Docket Item # 8
BAR CASE #2010-0280

BAR Meeting
October 20, 2010

ISSUE: Permit to Demolish (portion of rear elevation)

LOCATION: 429 South Lee Street

Figure 2. Existing rear elevation - second story is area proposed for demolition.

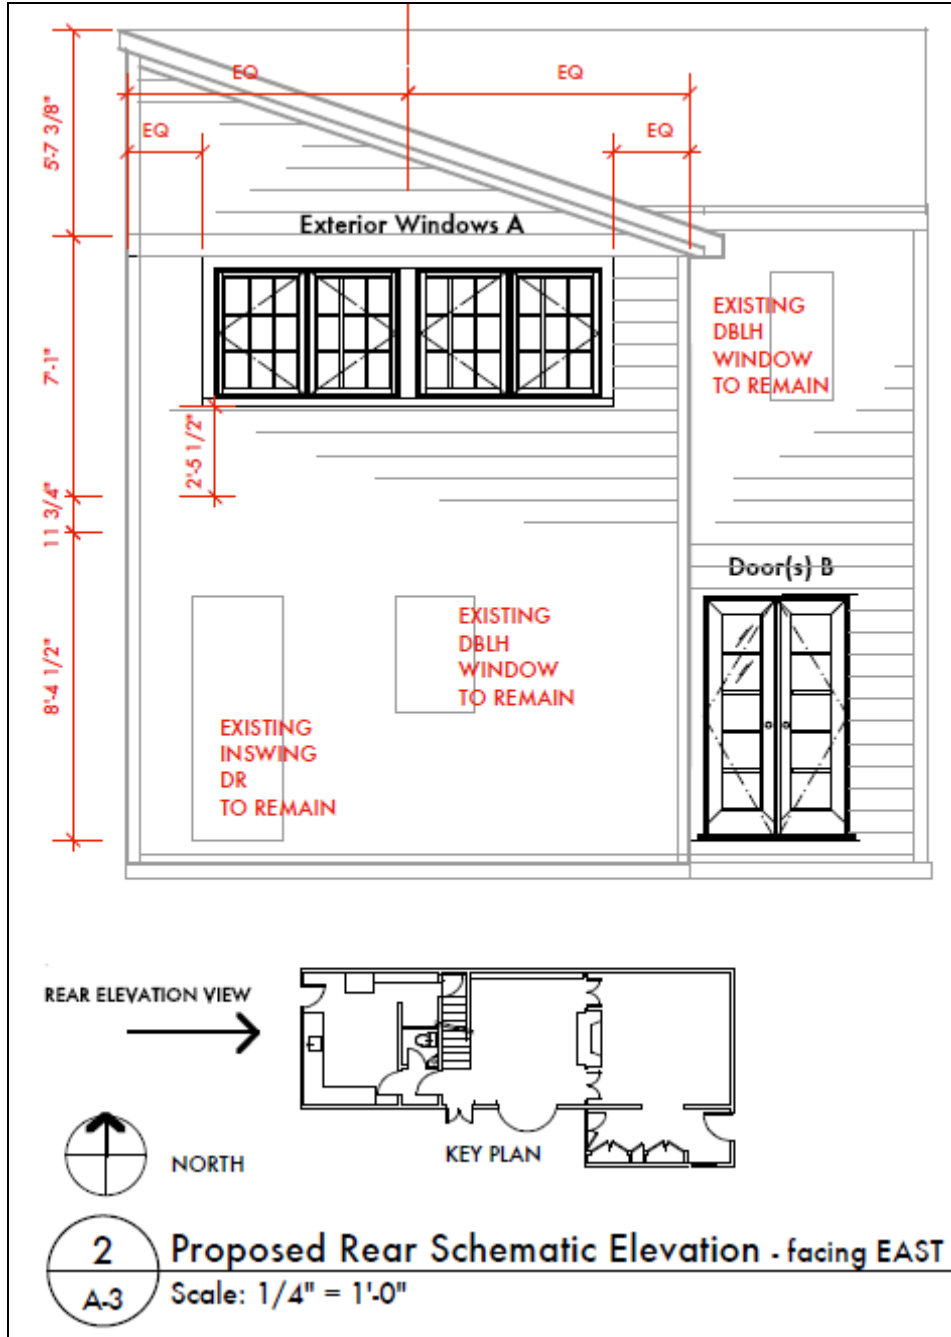
The applicant is requesting approval of a Permit to Demolish to demolish a portion of the rear elevation of the townhouse located at 429 South Lee Street to enlarge a window opening. On the second story of the rear ell, the applicant proposes to replace a single window opening with two sets of paired casement windows. Initially, the applicant proposed to expand a single door into French doors on the first story but has since withdrawn that portion of the application. **The total area of proposed demolition is approximately 36 square feet.**

In the opinion of Staff, none of the criteria for demolition and encapsulation are met and the Permit to Demolish/Encapsulate should be granted. The area proposed for demolition/encapsulation is modest in scope, located on a secondary elevation, does not remove any portion of the building

containing character defining features of uncommon design or historic merit, and does not compromise the integrity of the building as a whole. The siding, in this case, does not appear to be original. While Staff notes that the cumulative effect of piecemeal demolition can erode the integrity of a building, Staff finds that the amount of proposed demolition is acceptable.

STAFF RECOMMENDATION: Staff recommends approval of the application as submitted.
